To:	Gene Sams, Nick Bowmar, Lynley Fletcher (Meridian Energy)	Job No:	1016884.1000
From:	Pushpaka Rabel (T+T)	Date:	7 September 2023
cc:	Maurice Mills (T+T), Nick Peters (T+T), Hayden Sander (T+T), Tom Anderson (Incite)		
Subject:	Mt Munro Wind Farm Stormwater S92 Responses

MOUNT MUNRO CONCEPT DESIGN POTENTIAL CULVERT LOCATIONS

Appendix A – Request 90: Plan

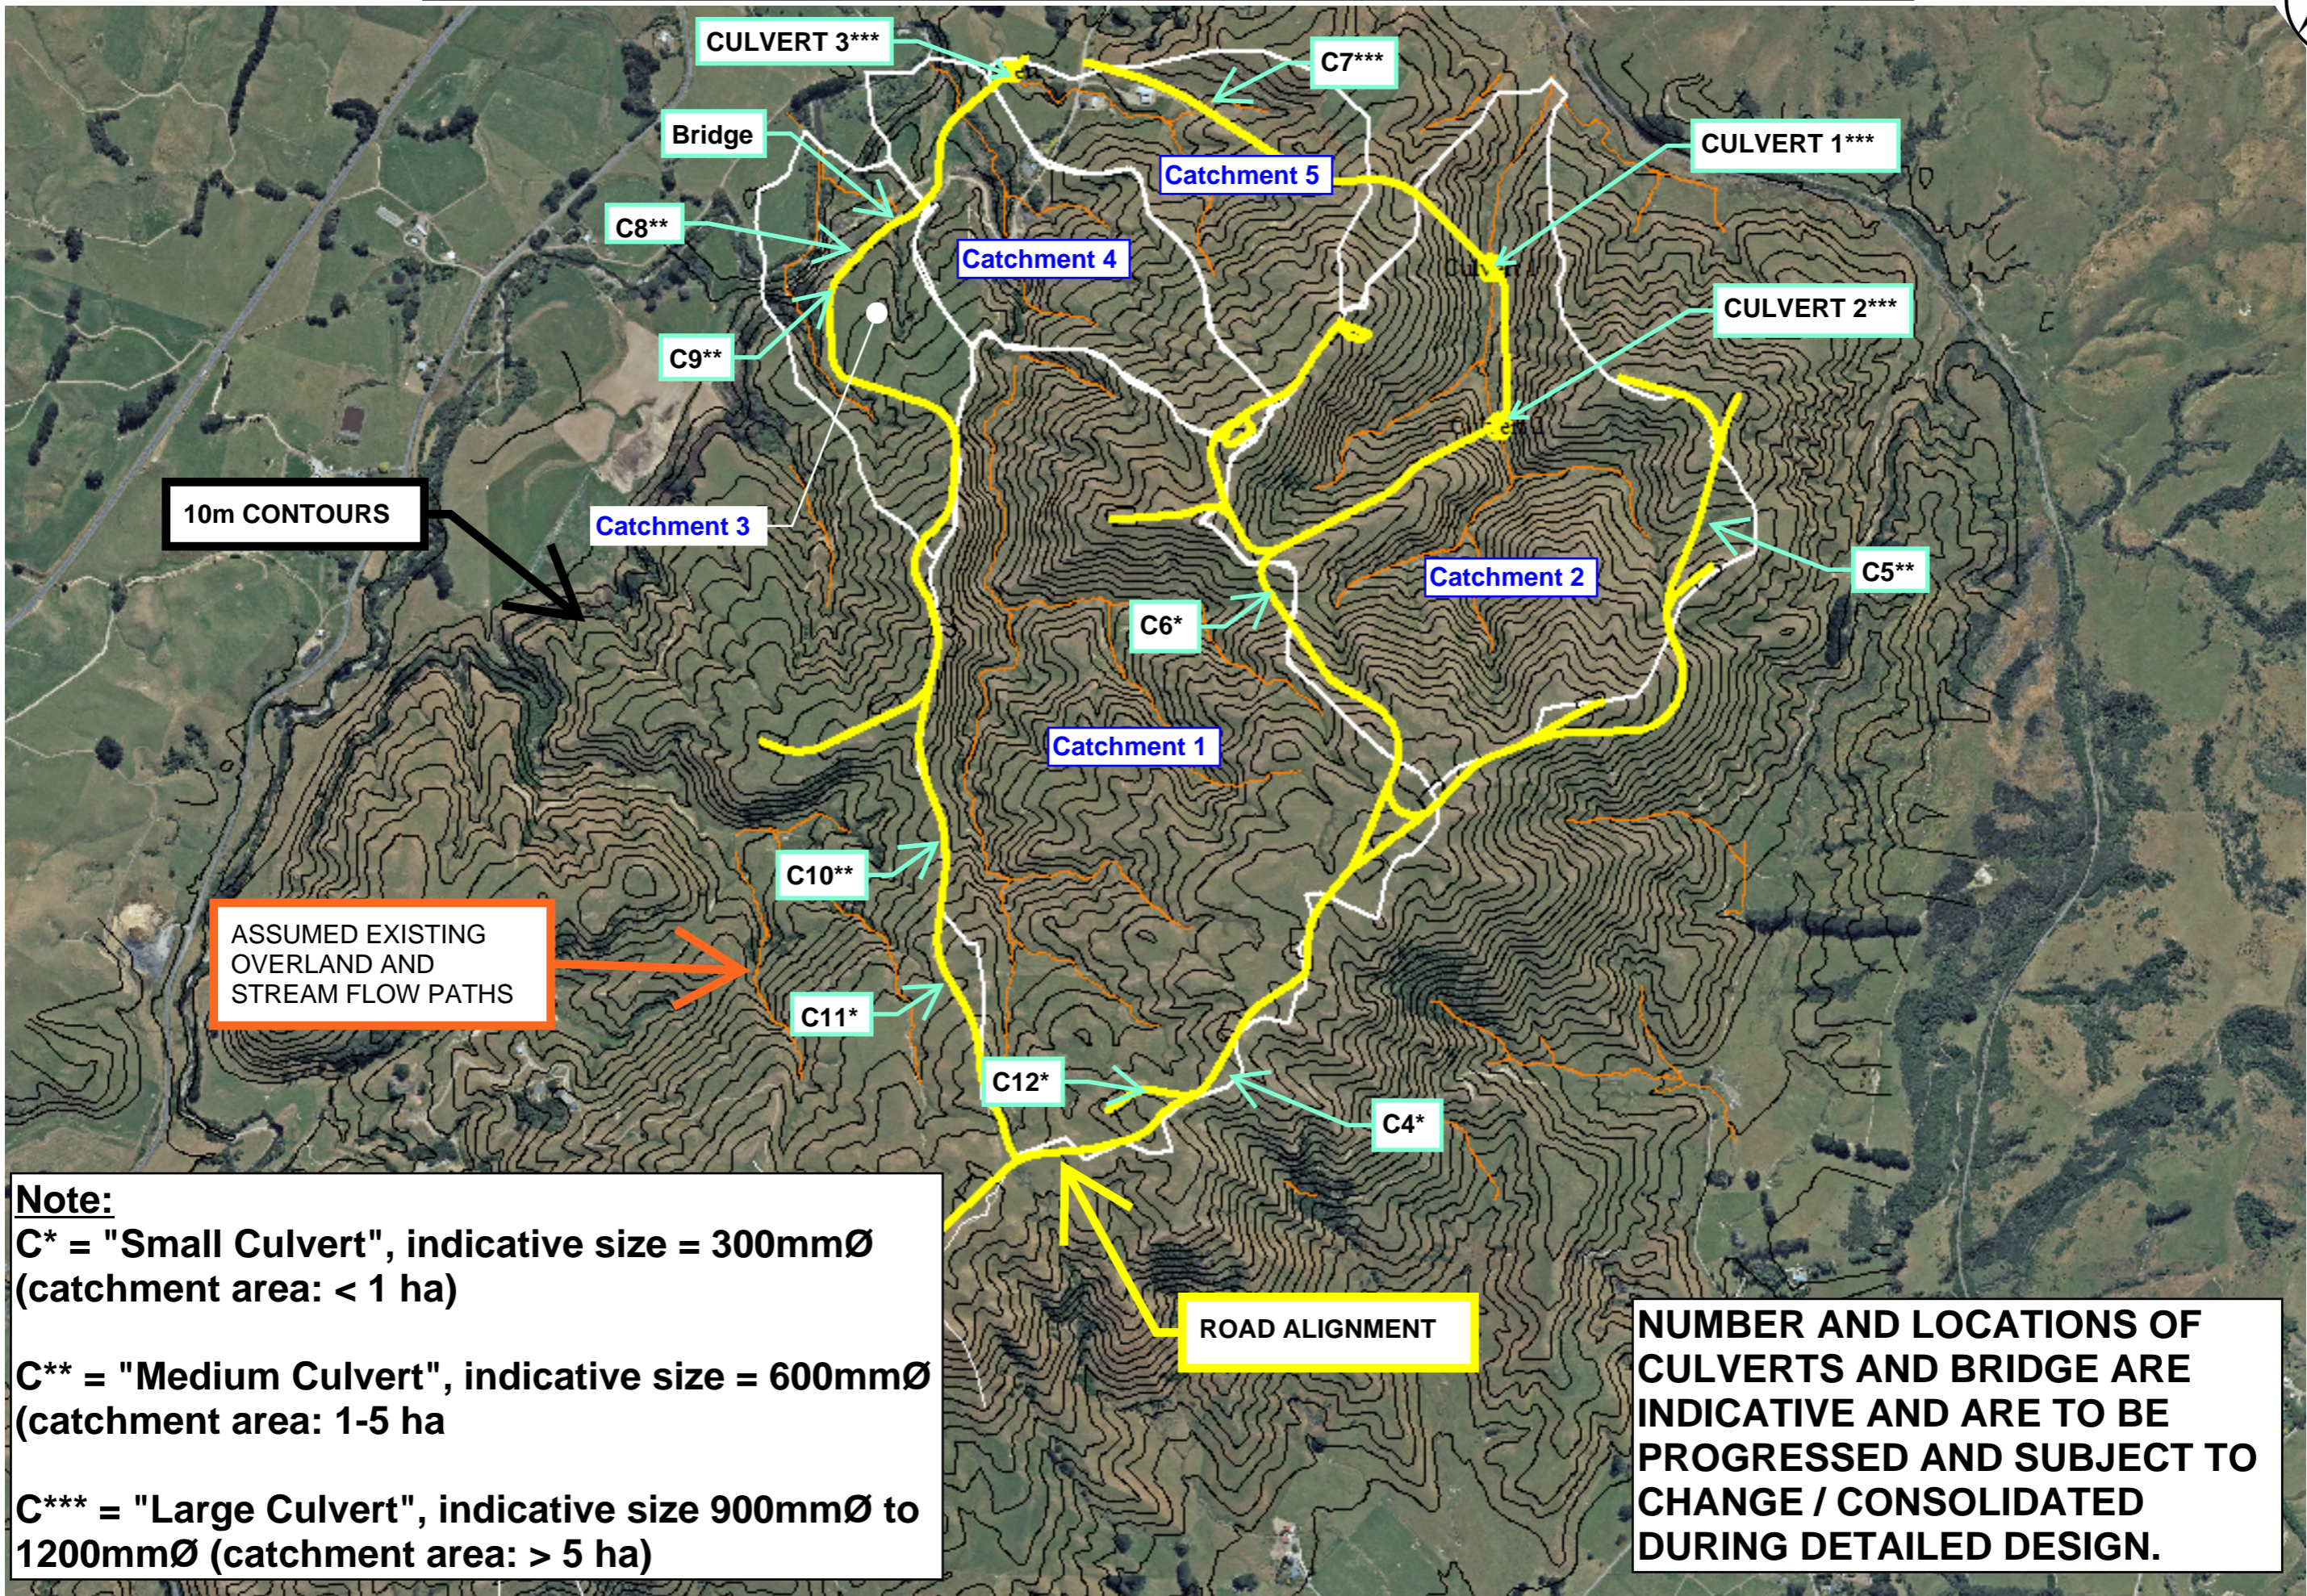
“90. Based on observation on site and a desktop review of the available LiDAR information, there is likely to be a number of additional culvert crossings which are not indicated in the application. For example, east of Culvert 3, there appears to be an additional stream crossing that hasn’t been mentioned in the application (as indicated with the red circle in the screenshot below). More detailed maps should be provided showing the topography with contours and identifying any other culvert crossings that may be required for the project, within the road alignments or other areas where land modification is proposed.”

Appendix A contains a map which shows the main catchments within the project area, ground contours at 10m intervals, flow paths, the proposed road design alignment along with associated areas of cut and fill, the location of a potential bridge, the locations of the major culverts (Culvert 1, 2 and 3) and locations of potential additional smaller culverts. These are indicative only at this stage of the design and are to be confirmed during detailed design.

- A bridge may be required at the north-west area and be suitably sized to service the large catchment area anticipated and satisfy structural and fish passage requirements;
- Culverts 1, 2, and 3 are expected to service large catchments and maintain existing stream flows and/or flow paths and fish passage;
- The rest of the culverts identified service relatively small to medium-sized catchments (refer our response to RFI #91 below) and maintain existing stream flows and/or flow paths and fish passage, or are required to maintain overland flow paths.
